CITY OF MILLS – PLANNING DEPT.

Staff Report — Midway Subdivision No. 2 (26-187)

CITY OF MILLS — PLANNING DEPARTMENT

Wyoming Classical Academy Phase II Development Plan

SHEET NUMBER
C500

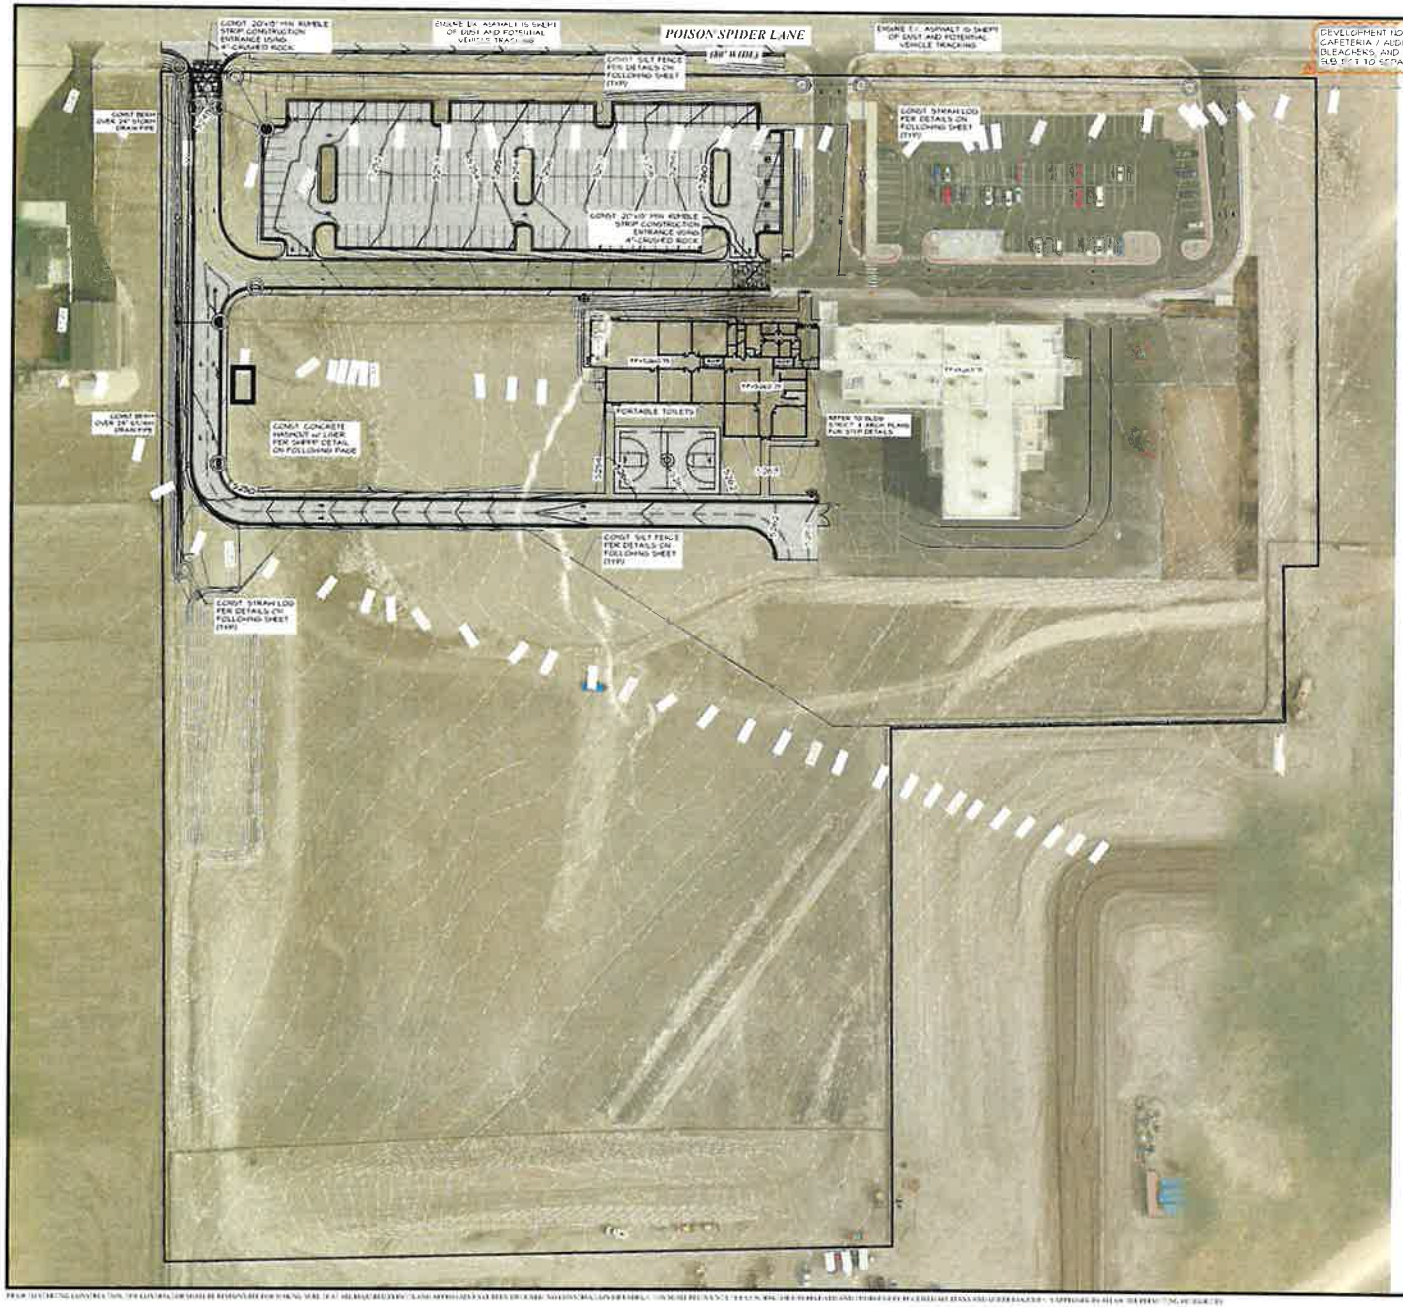
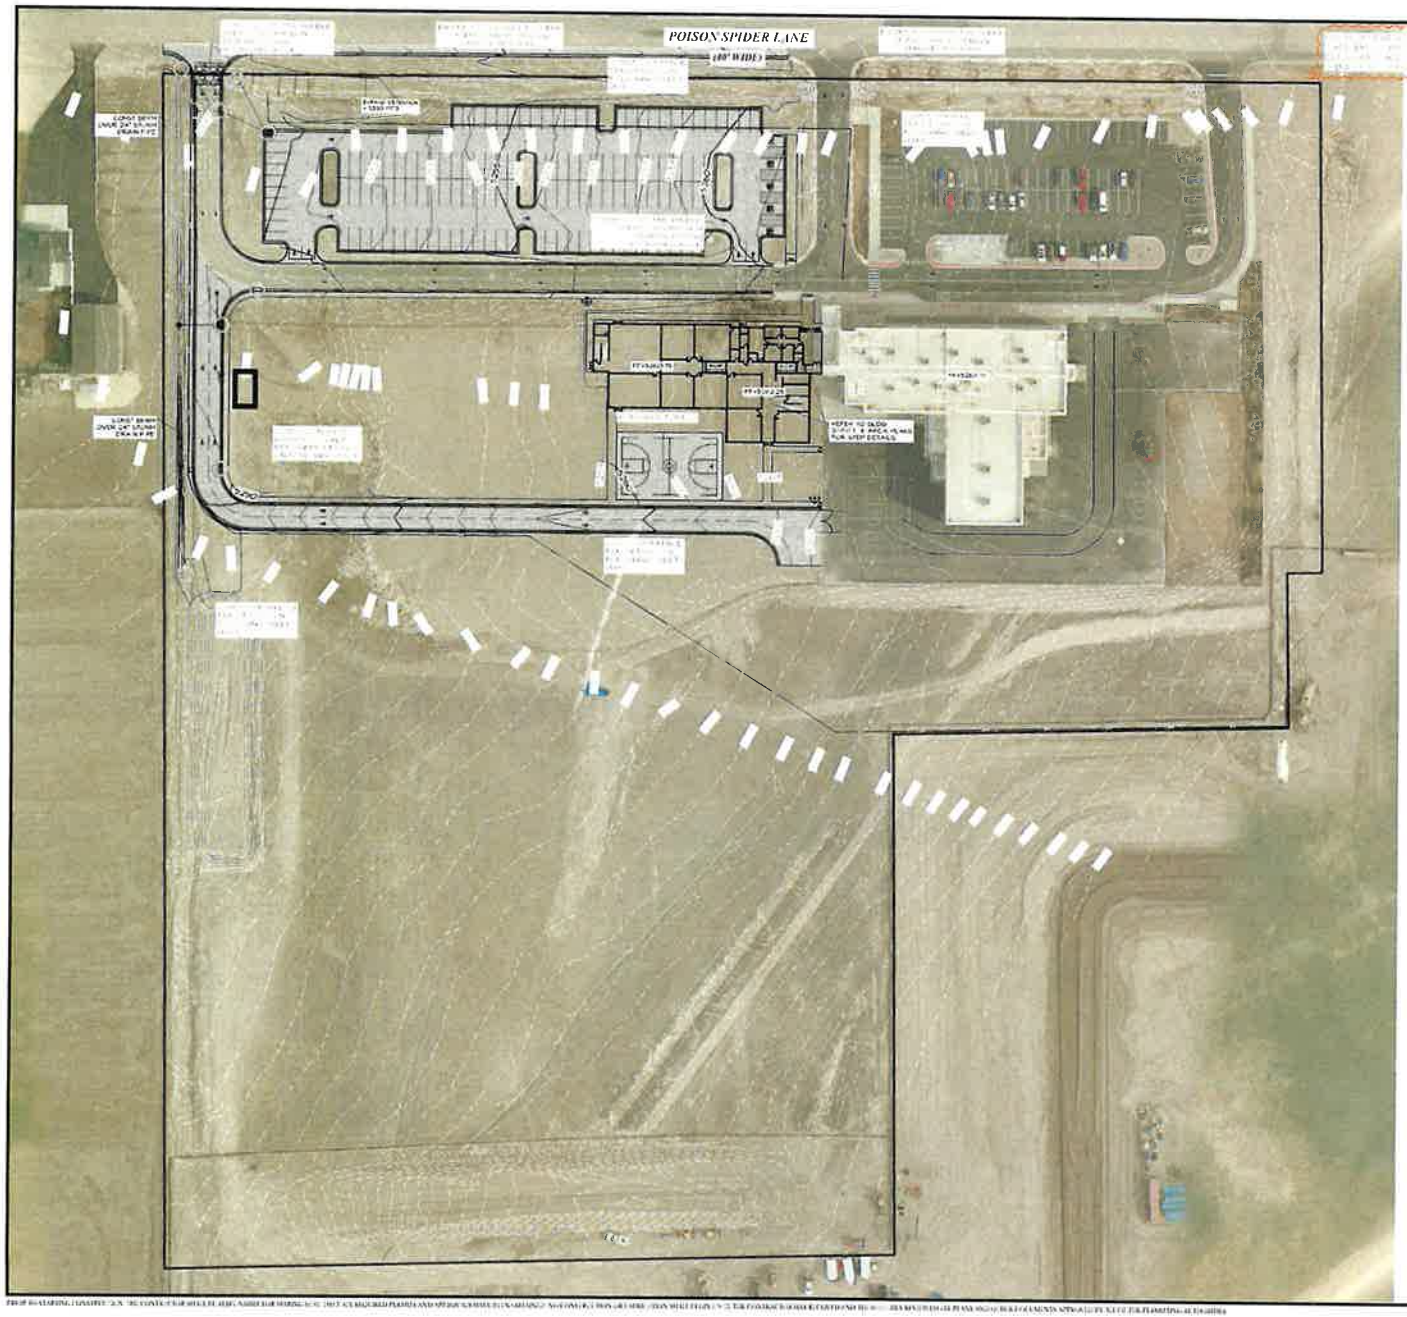
9. Park strip planting: The park strip planting from Sheet C500 carried onto the landscape plan, with species, size, and quantity.
9 Response: Planting is located on the south side of the park strip between parking lot and drainage ditch. See updated sheet L1.0

SHEET
L1.0

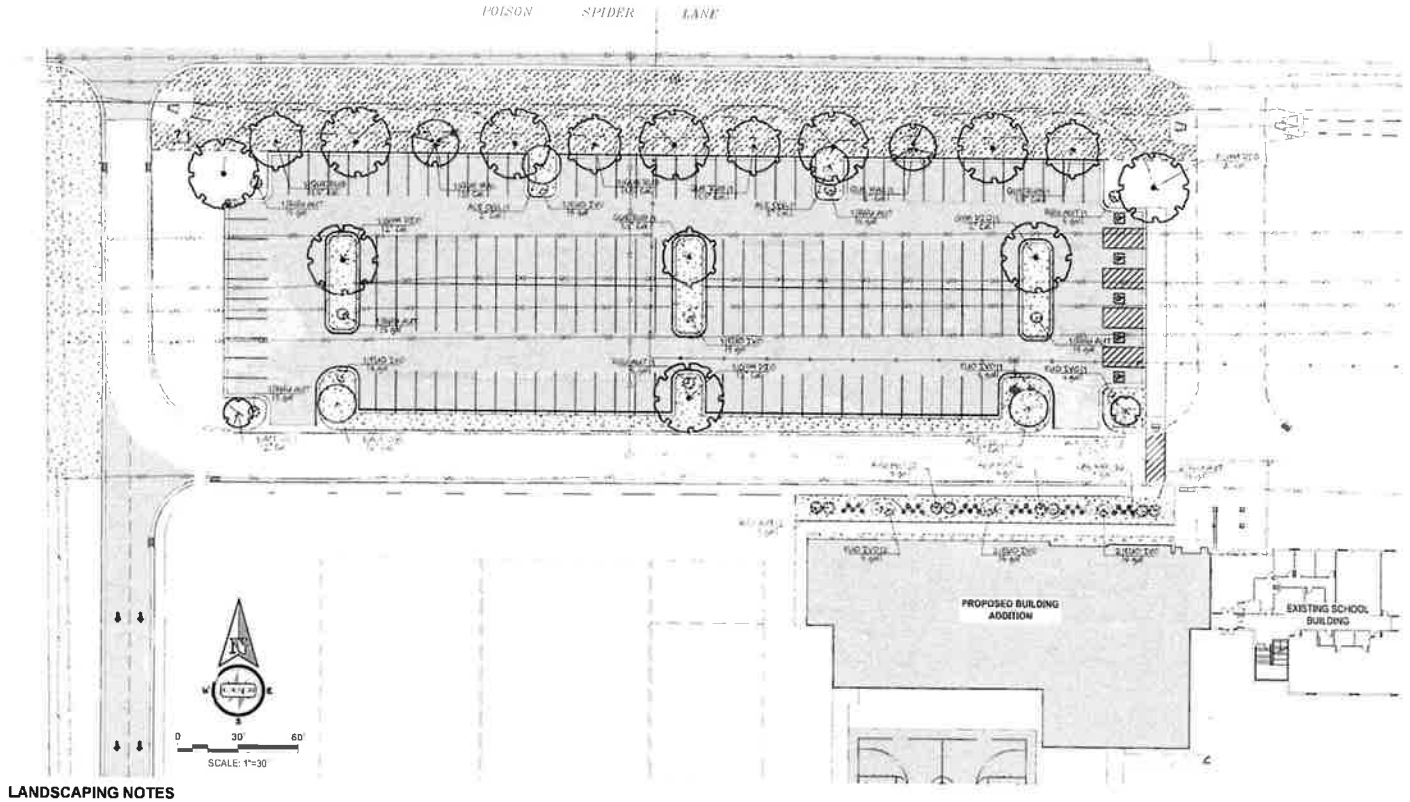
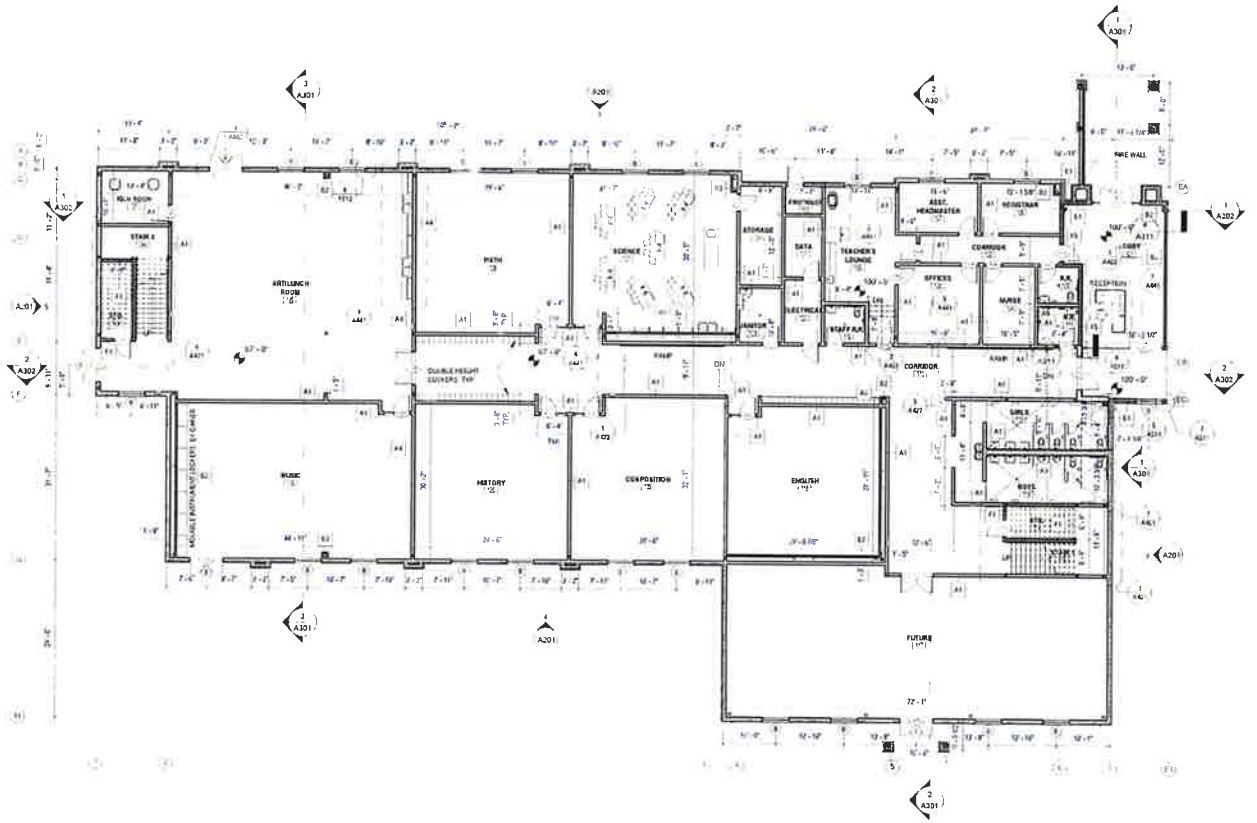
A plan note that defers irrigation design to construction does not satisfy the Commission. It asked to see the planting and the irrigation on the drawings.

7. Updated landscape plan: A current Sheet L1.0 that matches the redesigned site layout and shows items 8 through 11.
7 Response: See updated sheet L1.0

8. Island planting: The tree and shrub in each parking island, with species, size, and quantity. Show the gas lines that cross the islands and state what will be planted where a line limits planting.
8 Response: See updated sheet L1.0

10. Irrigation mapping: An irrigation plan showing the point of connection, mainline, zones, and the heads or drip lines serving the islands and the park strip.
10 Response: Landscape contractor to design and install irrigation system in accordance with the landscape plan. Note 4 & 32.

Section 40.40(4) describes the Landscape Plan as "not necessarily a construction document." It must be complete enough to show the design and to be enforced. Revised Sheet L1.0 provides the planting plan with the location, size, and botanical and common name of each plant, the ground covers, and the plant schedule. Every parking island has at least one tree and one shrub (§40.40(7)(d)(ii)). The parking rows are broken at 16 spaces or fewer. The 5-ft. perimeter strip along Poison Spider Lane is planted with a row of shade trees (§40.40(7)(e)). Rock mulch is about 34% of the landscaped area, under the 60% limit in §40.40(7)(b). No existing landscape is retained or credited (§40.40(4)(d); §10.40(6)).

Irrigation (Item 10). The Commission asked to see irrigation mapped on the drawings. Section 40.40(7)(h) requires that all planted areas be provided with irrigation systems. It is an installation standard. The contents of a Landscape Plan listed in §40.40(4) do not include an irrigation layout, and where Title 17 requires an irrigation plan, it says so (for example, §45.45). L1.0 Note 4 commits to an irrigation system designed and installed to serve the plantings, with as-built drawings submitted on completion. Staff finds that this meets Title 17 at the development plan stage. Irrigation will be verified at installation.

Requests for a statement on planting over the gas lines and for planting in the right-of-way park strip also go beyond what Title 17 requires of a Landscape Plan. Note 8 on L1.0 keeps plantings 5 ft. from underground utilities during construction, and §40.40(7)(i) makes the owner responsible for maintaining the adjacent right-of-way.

E101

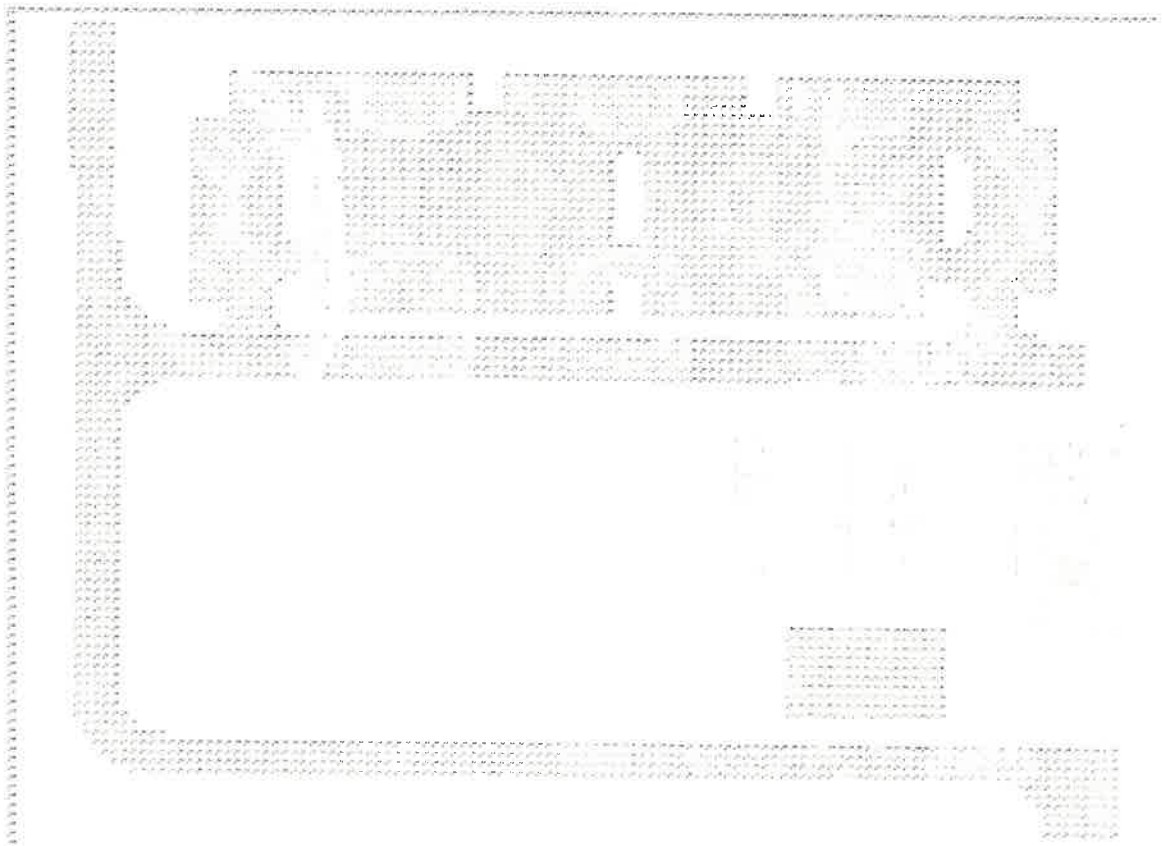
12. Layout: Lighting plan updated to the current site layout.
12 Response: The electrical site plan and photometric site plan have been updated to match the current site layout; see E101 and E102.

16. House-side shielding: Shielding shown on the fixtures that face neighboring property.
16 Response: Manufacturer house-side shielding has been added to all fixtures within 150' of the north and west property lines; see E101.

- Light trespass: the photometric grid extends 5 ft. past the north and west property lines, the residential sides. The maximum there is 0.08 fc, below the 0.2 fc limit (§40.35(3)(d)).
- Height near residential: all poles are 15 ft., with fixtures at 17 ft. above grade (E501, E101, E602), which meets §40.35(5)(a).
- Shielding: manufacturer house-side shields are specified on the north and west fixtures (§40.35(5)(b)).
- Controls: astronomic time-clock control from the lighting control panel (§40.35(3)(a)).
- Plan contents: fixture types and output (E501), cut sheets, locations and mounting heights (E101), and a narrative were provided (§40.35(4)(a)).
- Play area: the A3 court fixtures are included in the plan and calculations. Light from the court stays on site.

6 POLE BASE
E602 NOT TO SCALE

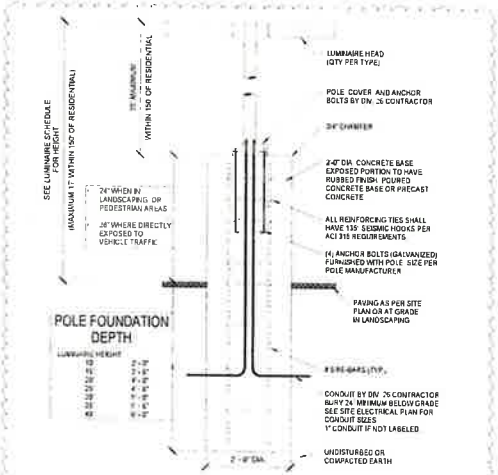
15. Pole and base heights: Pole height and base height for each pole type.
15 Response: Pole base detail has been added to E602. Maximum base heights and fixture heights have been added to this detail for clarity.
